Gibbons Creek Environmental Redevelopment Group, LLC

April 19, 2024

Re: Technical NOD5 New CCR Registration
Gibbons Creek Environmental Redevelopment Group, LLC – Anderson, Grimes County
New Coal Combustion Residuals (CCR) Registration No. CCR113
Industrial Solid Waste Registration No. 32271
EPA Identification No. TXD000751073
Tracking No. 27262344; RN100214550/CN6505860162

32. 2023 Groundwater Report and Attachment S

HYDROGEOLOGICAL
CROSS SECTION A-A'

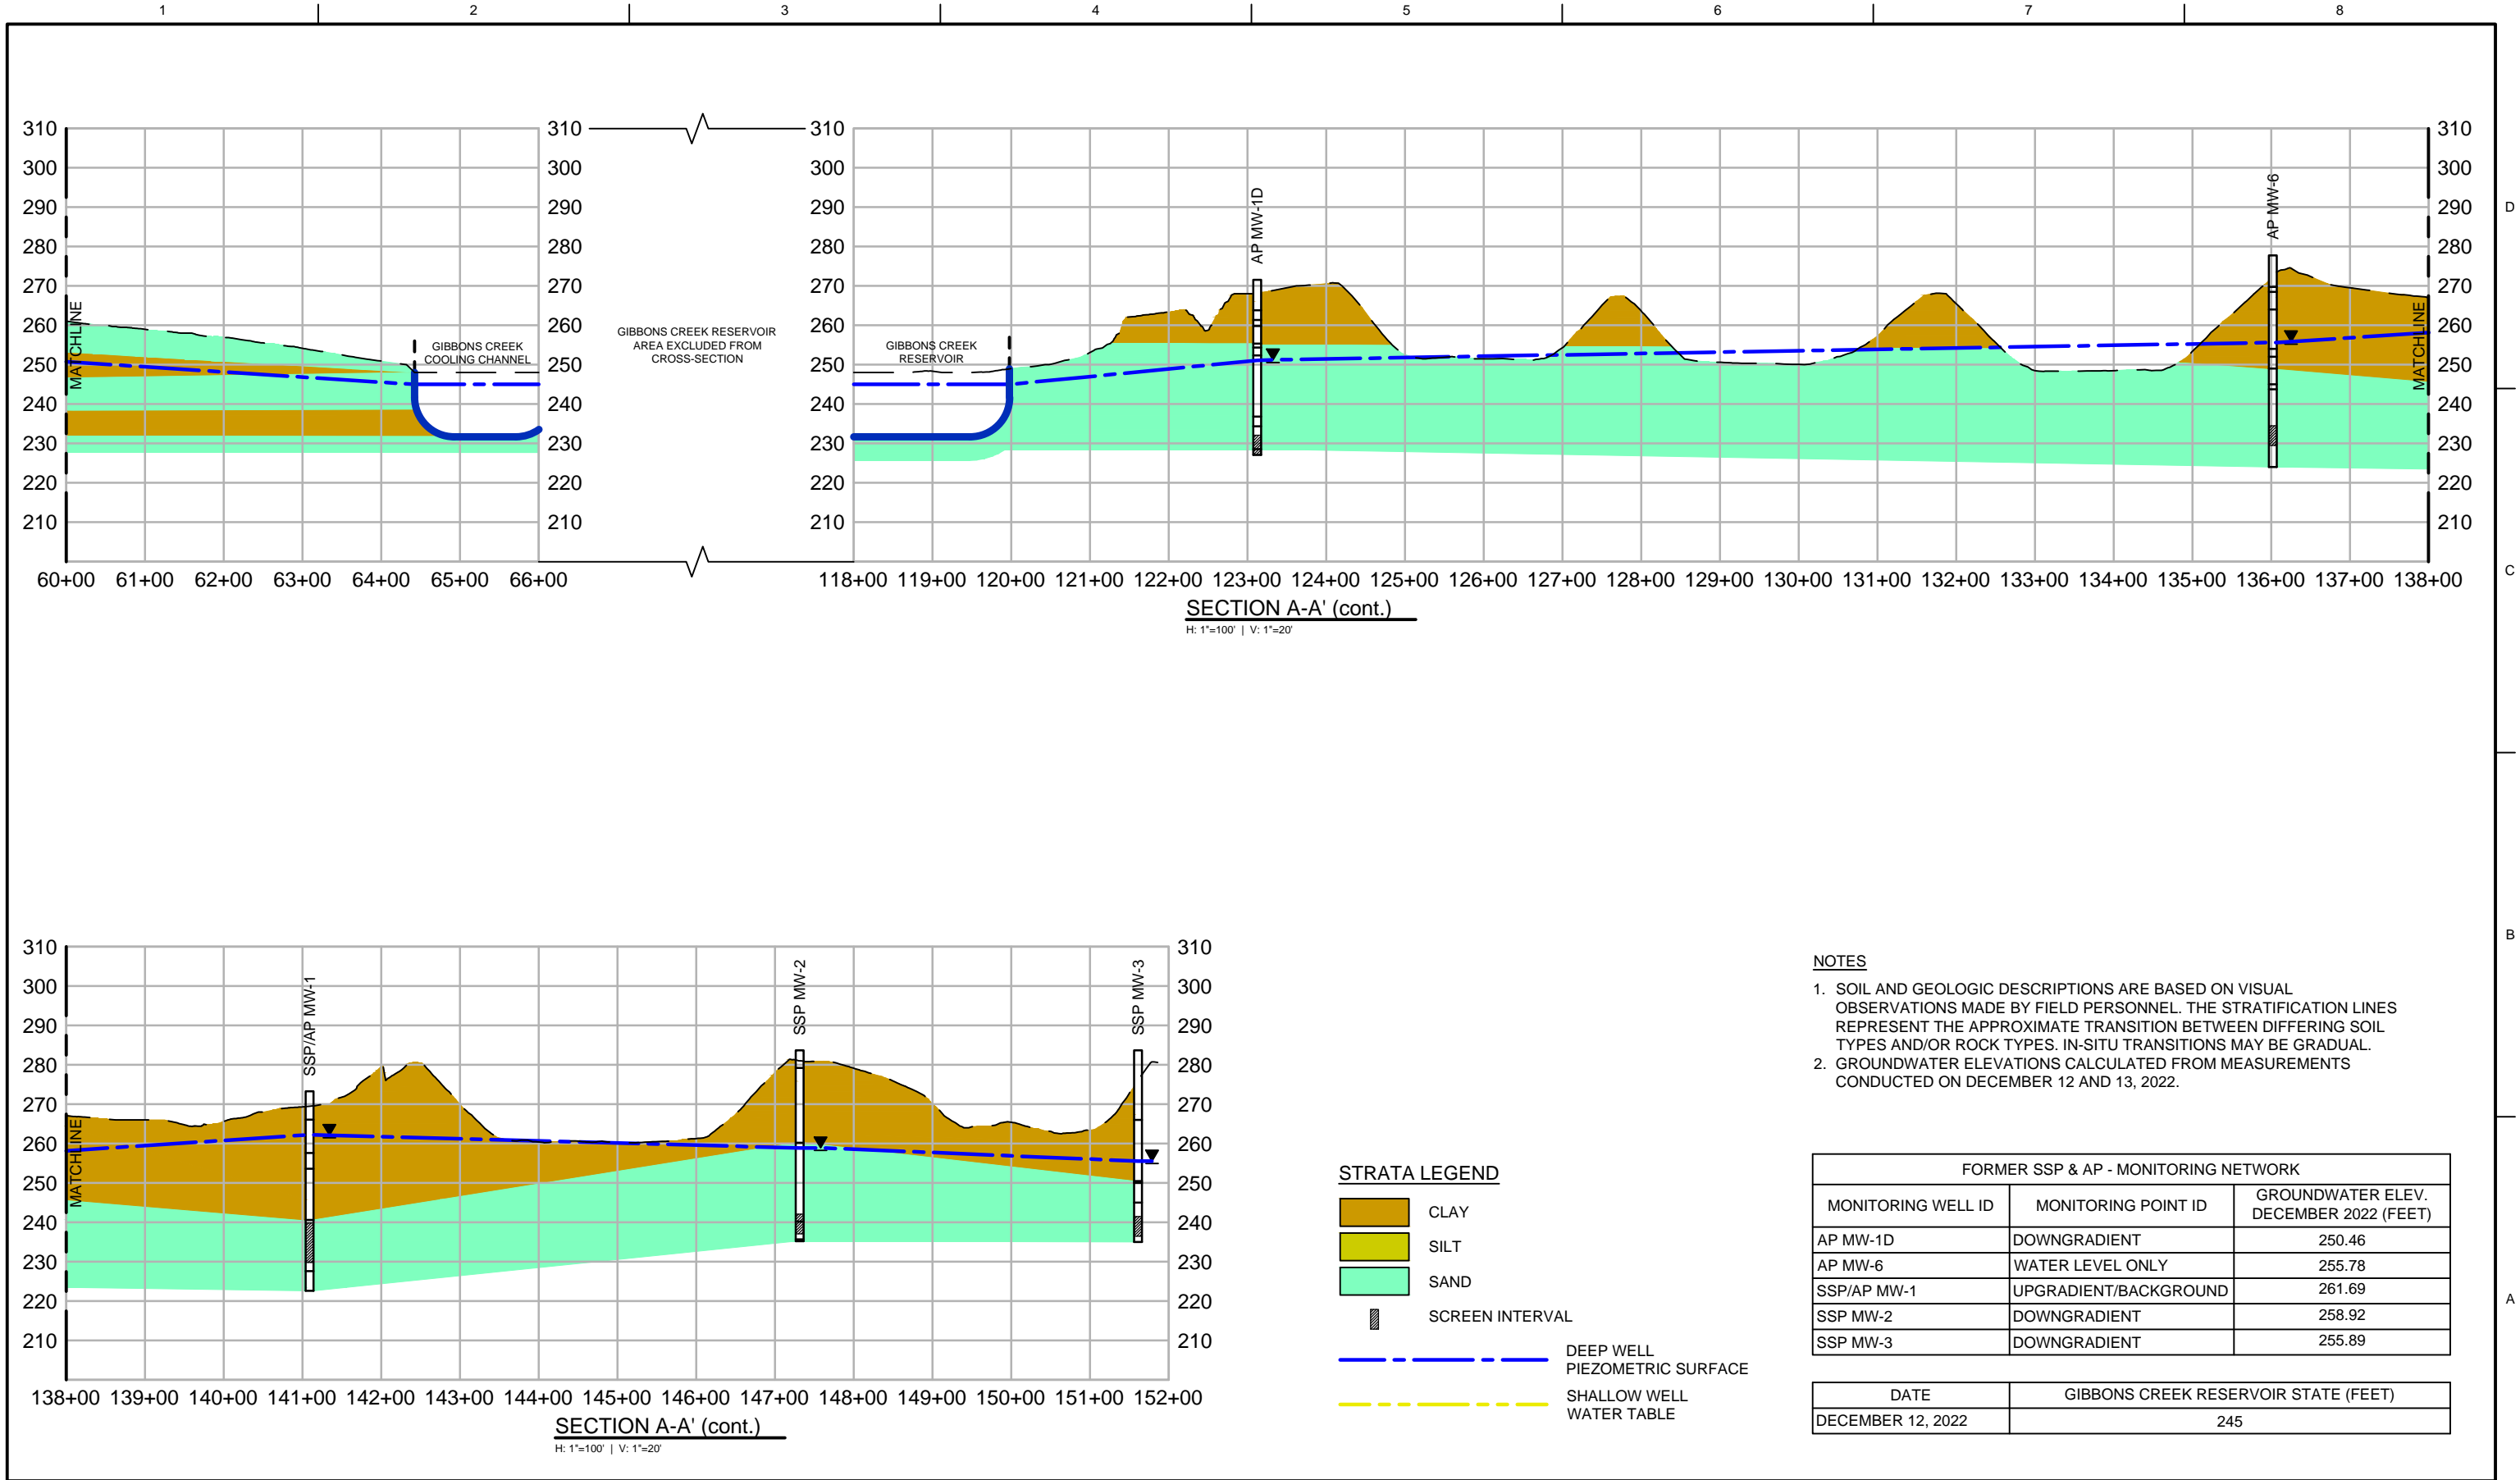
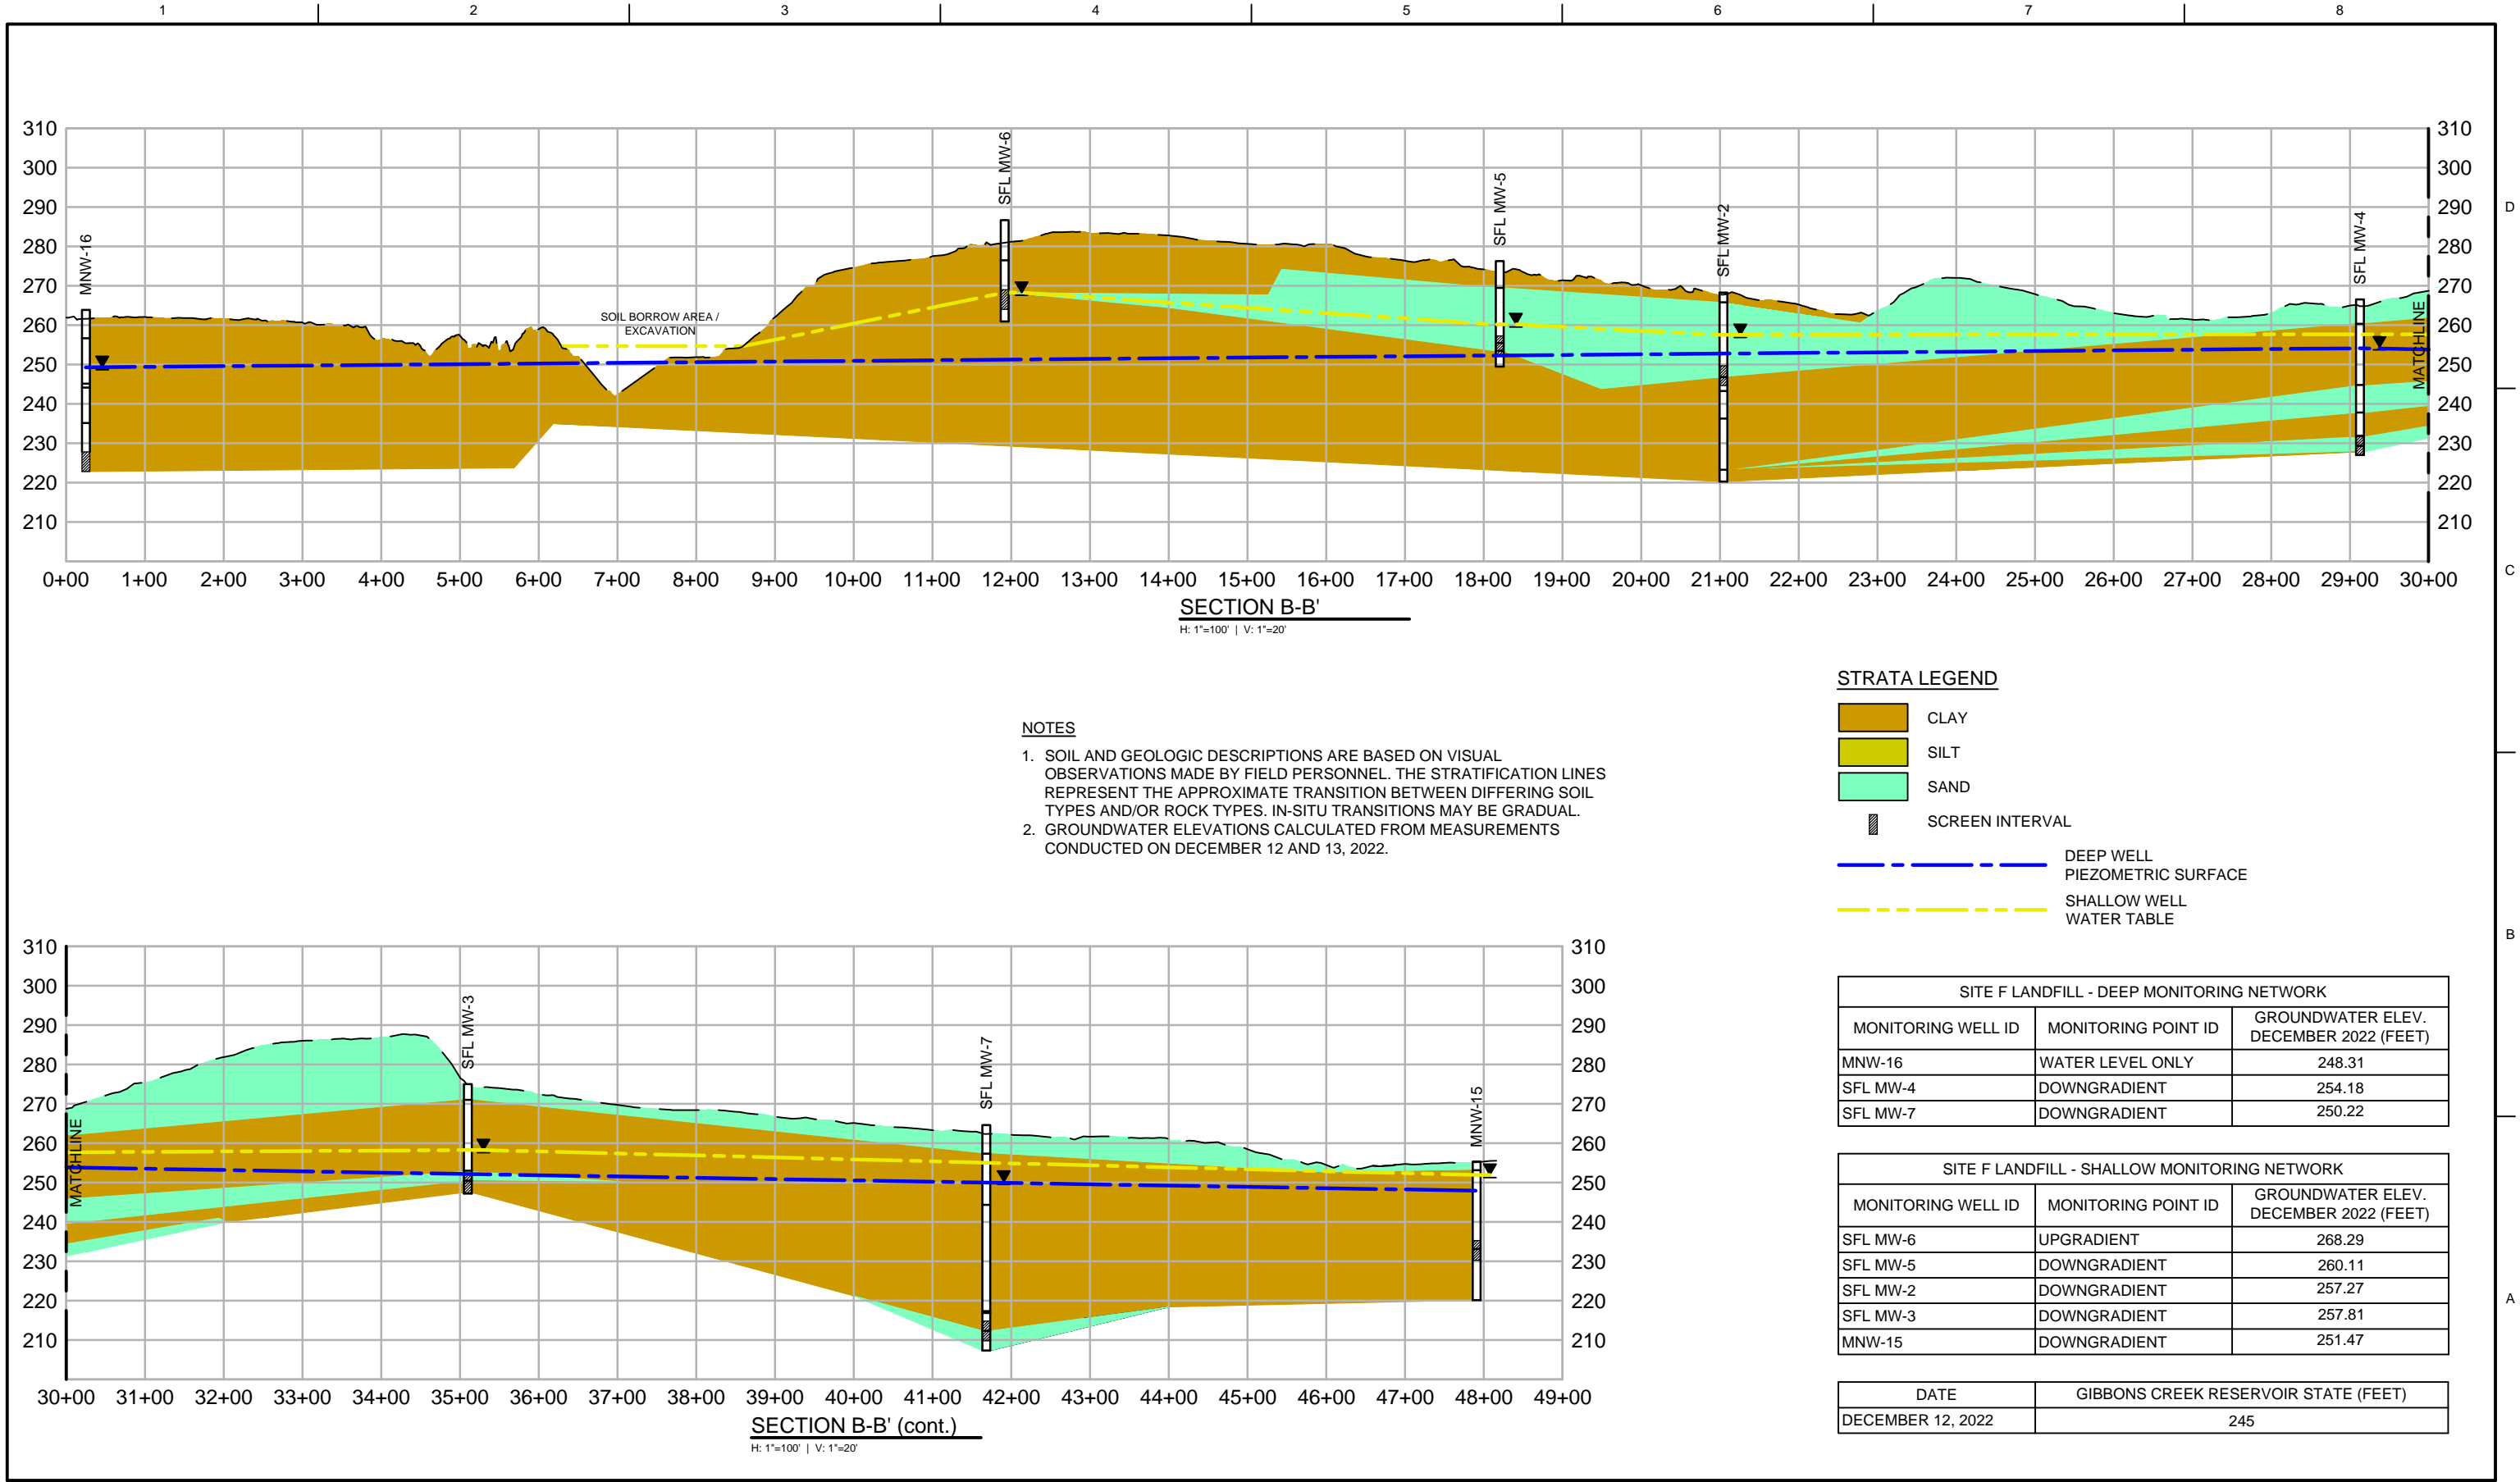
- a) Provide and explanation for how the facility would address two groundwater monitoring systems if the existing monitoring wells for Site F Landfill were not monitoring the same strata (shallow and deeper zones) based on well depths and screen depth intervals. Provide cross sections that clearly show the delineation of two different layers including well location, water level, and well/screen depth for each monitoring well.

Please see “CCR Groundwater Monitoring System” document in Response Item No. 32 Attachment A for the description of the shallow and deeper groundwater networks at the Site F Landfill. Cross sections delineating the two different layers, including well location, water level, and well/screen depth for each monitoring well are included in the attachment.
